STREET A PLAN AND
PROFILE

PARKER RIDGE
82 SCHOOL STREET
ROLESVILLE / NORTH CAROLINA / 27571

08/01/2023 PER TOWN OF ROLESVILLE COMMENT

ALLEY 1 PLAN AND PROFILE

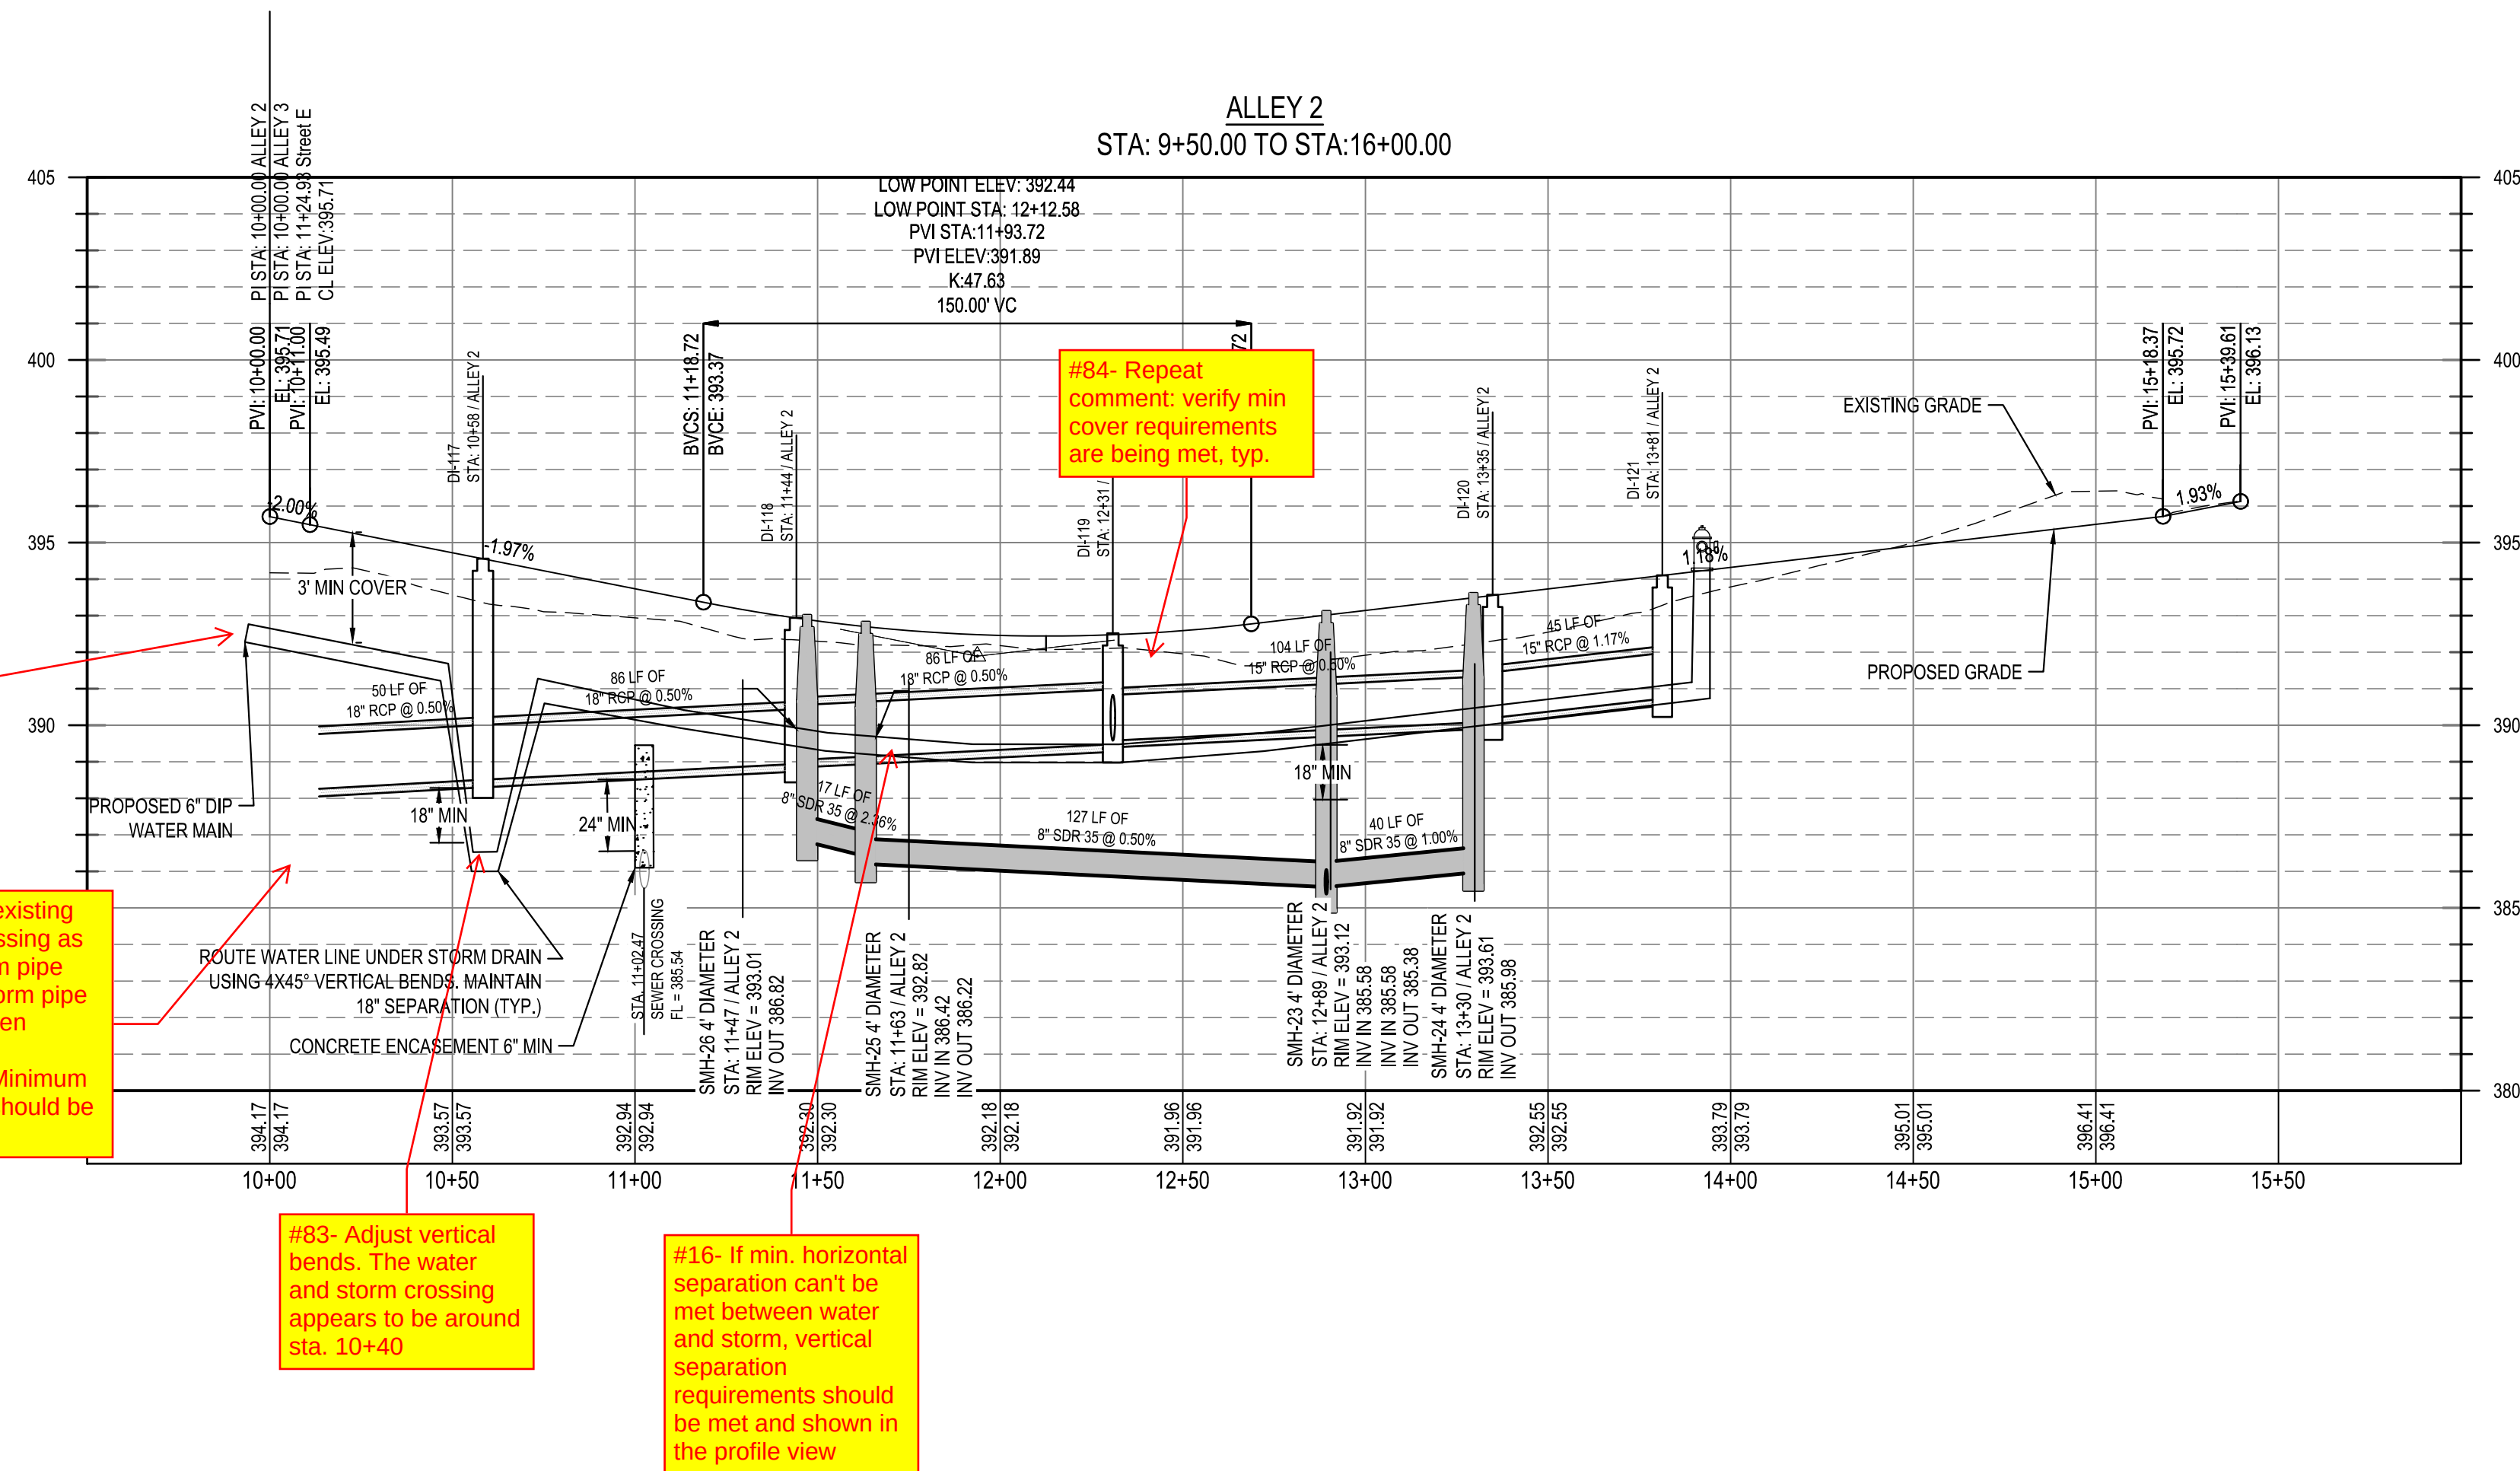
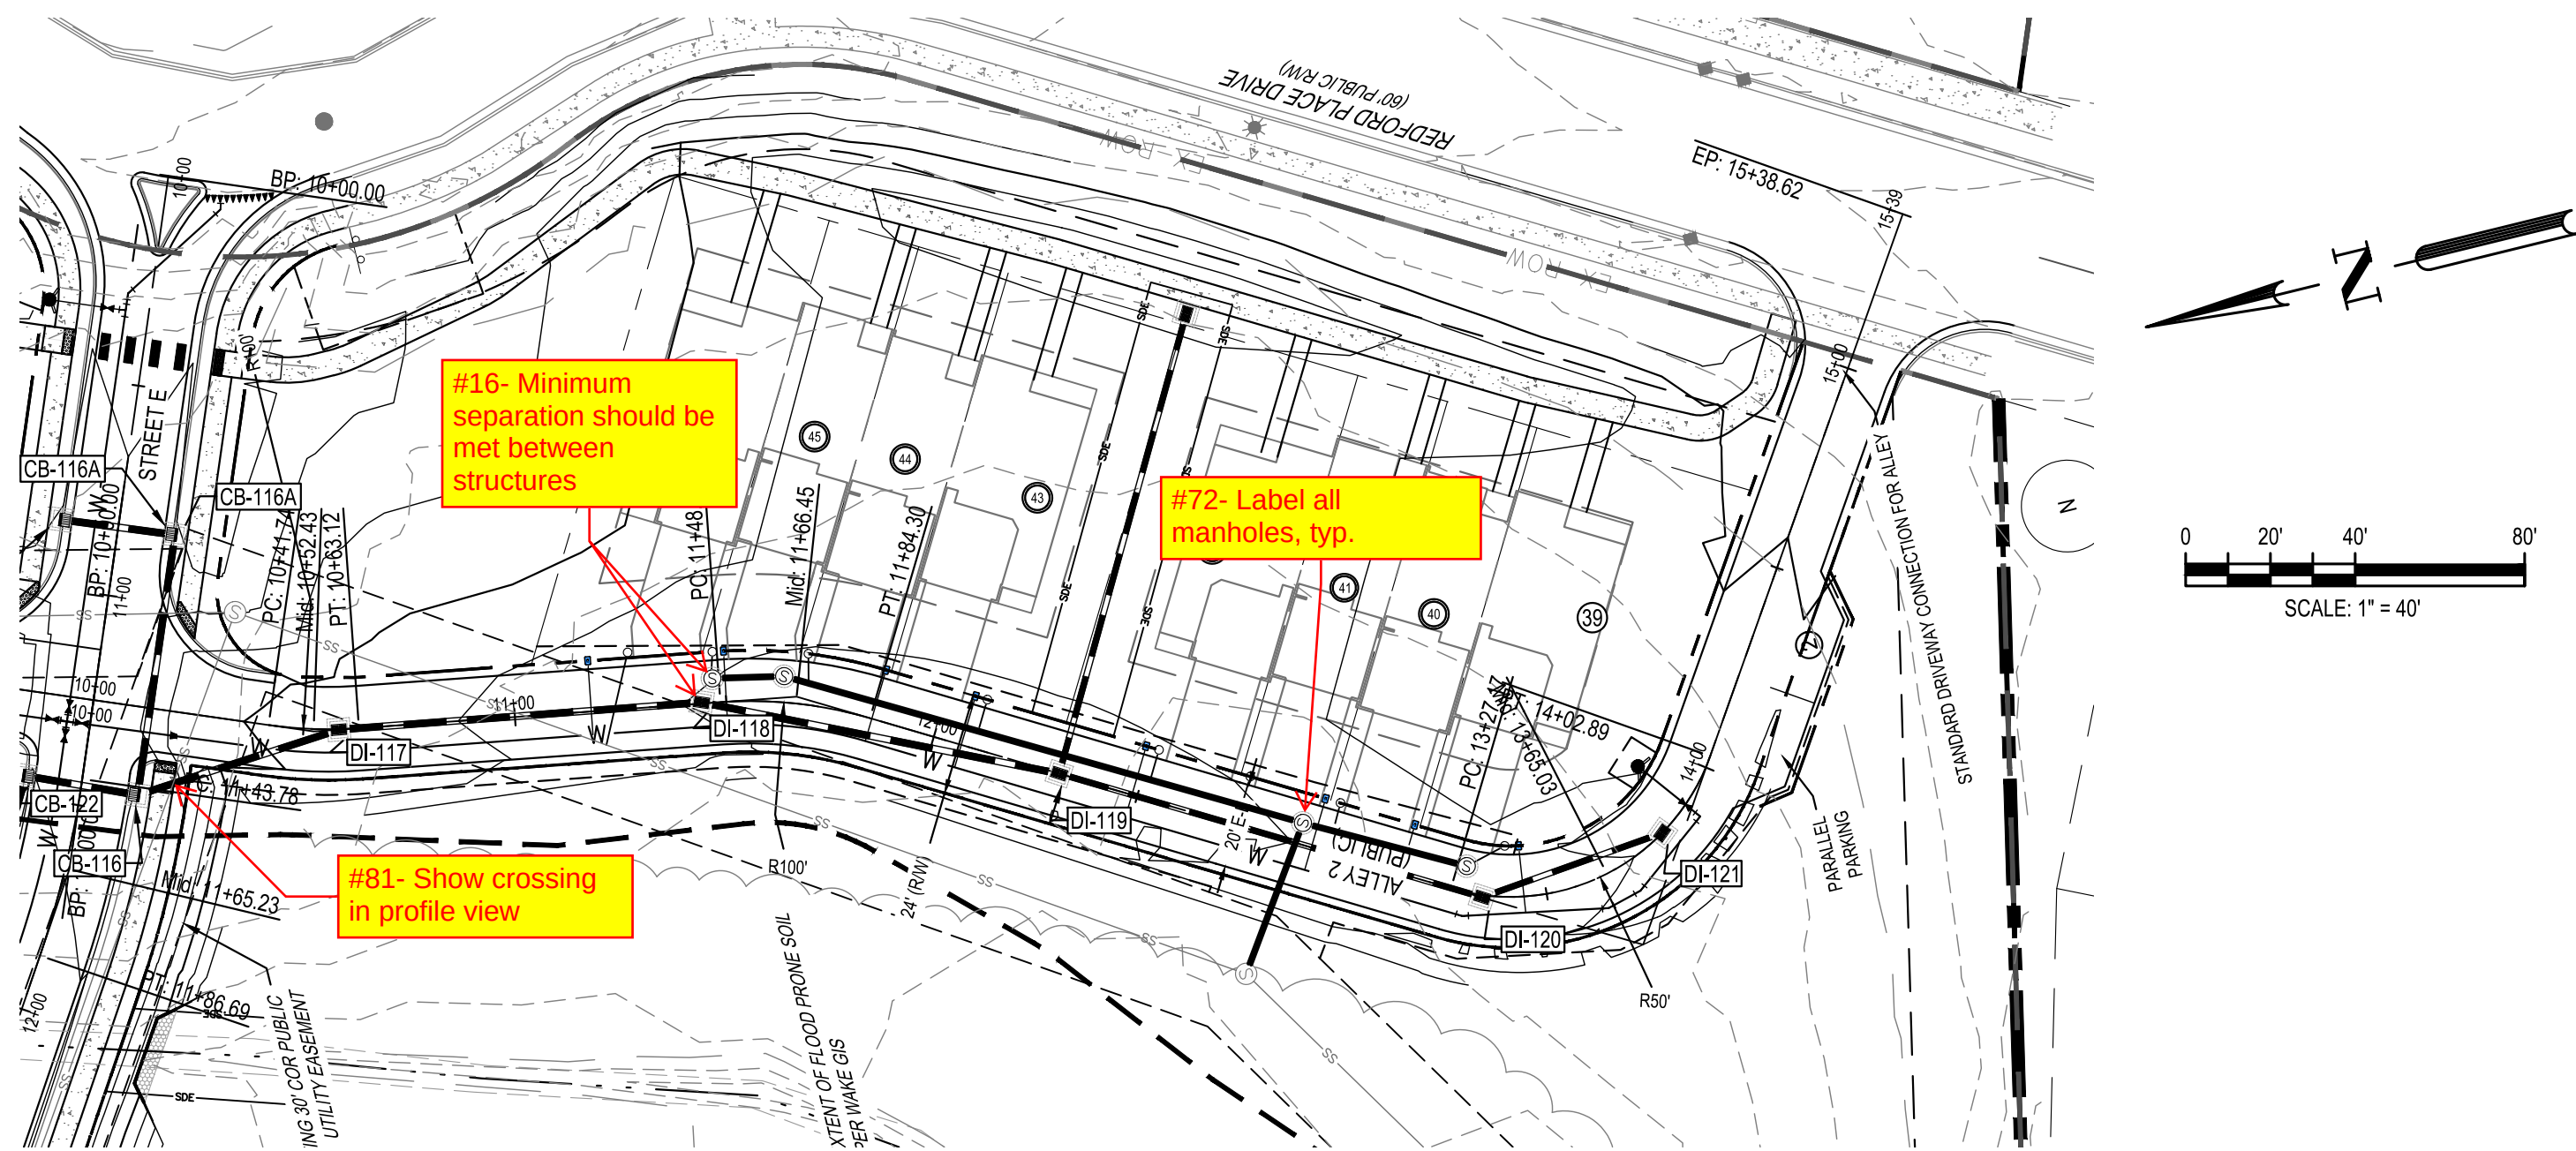
#62- There are several locations where the dimensions don't seem to line up with top/bottom of pipes. Please make sure it is clear what is being dimensioned. If crossings are not meeting minimum requirements, design will need to be adjusted.
